2500 N. HOLLYWOOD WAY – DUAL BRAND HOTEL PROJECT

FINAL ENVIRONMENTAL IMPACT REPORT

REVISED NOVEMBER 2026

Section 2.0 Comments on Draft EIR and Responses 2-1
2.1 List of Commenters 2-1
2.2 Comments and Responses 2-1

EXHIBIT A

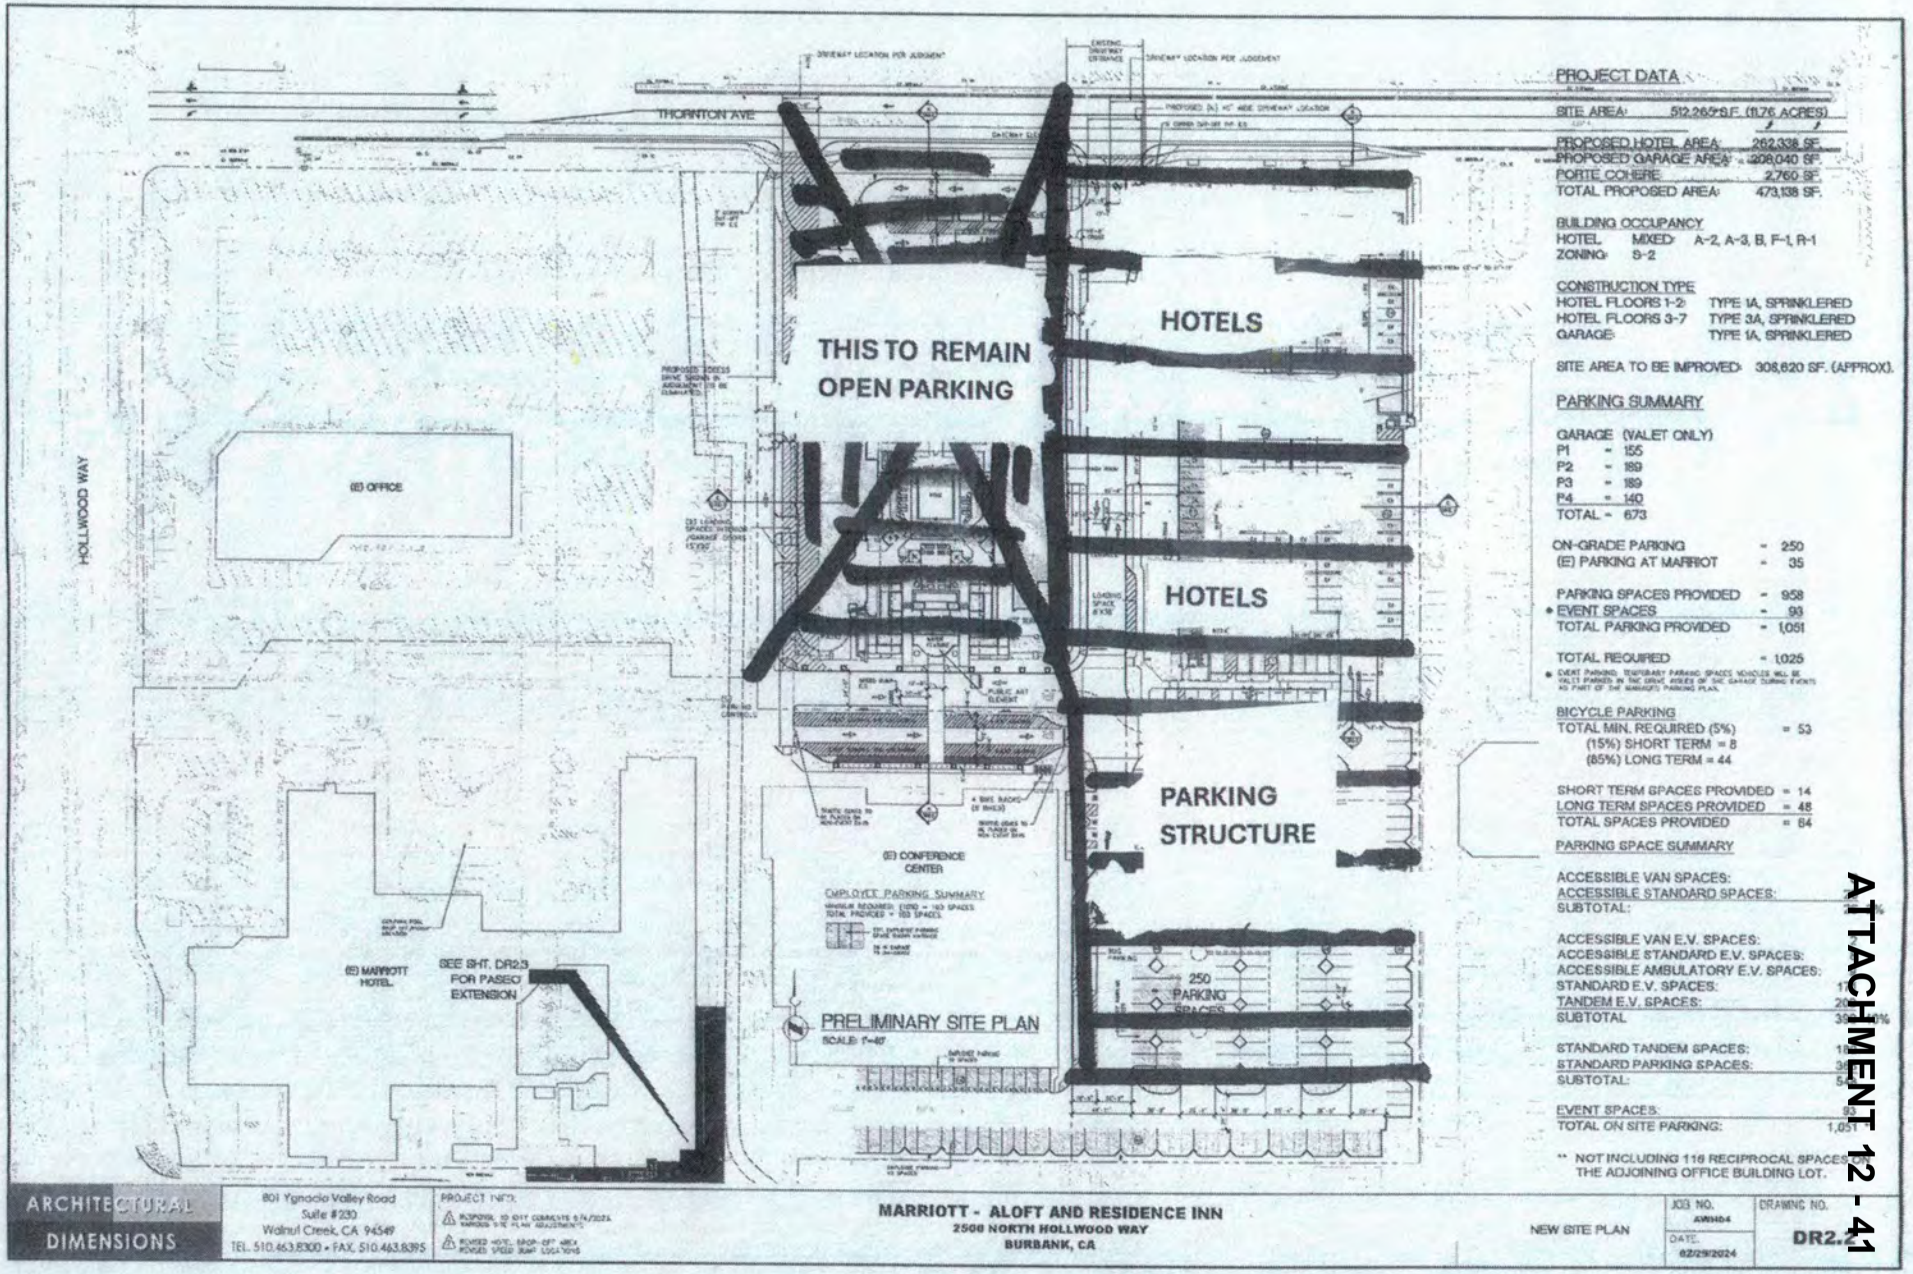
Relocating the 2 [proposed] Hotels and Parking Structure, as set forth above, would result in a far superior Project as it would mitigate many of the concerns and objections of the Office Parcel. I attach hereto a site plan taken from the DEIR where I have outlined the area the Office Parcel believes must be studied and approved. I believe the area I have outlined has approximately the same land area as is the currently proposed Project.

The comments reference the Draft EIR Project Alternatives and identifies the commenters preference for consideration of an alternative site layout (included as an exhibit to the comment letter) wherein the Hotel and Garage are sited to the east of the existing convention center to provide a farther distance from the Office building owned by SHG LLC when compared to the currently proposed location within the Project site. The commenter also incorrectly asserts that the alternative site layout "must be studied as a Project Alternative and legally sufficient reasons must be provided it the alternative of relocating…is not approved by the City and the Applicant."

Furthermore, the proposed Project could not be relocated directly east of the convention center, as the commenter suggests, because the proposed Hotel would not fit in that space, which is too narrow to accommodate the proposed footprint. Refer to the figure included at the end of the responses to this comment letter. The site is also not deep enough to accommodate the proposed Hotel and Garage to be situated end-to-end north to south from Thornton Avenue to the parcel's south property line. Moving the Hotel away from Thornton Avenue would have the potential to adversely impact traffic circulation within the site as the valet would not be right at the driveway, forcing all drop-offs to venture farther into the site, in addition to circulation issues caused by locating the Hotel drop-off farther from the street than the Garage. Therefore, the proposed location of the Hotel and Garage is the only option with enough space to accommodate the proposed Hotel footprint and avoid circulation issues within the site.
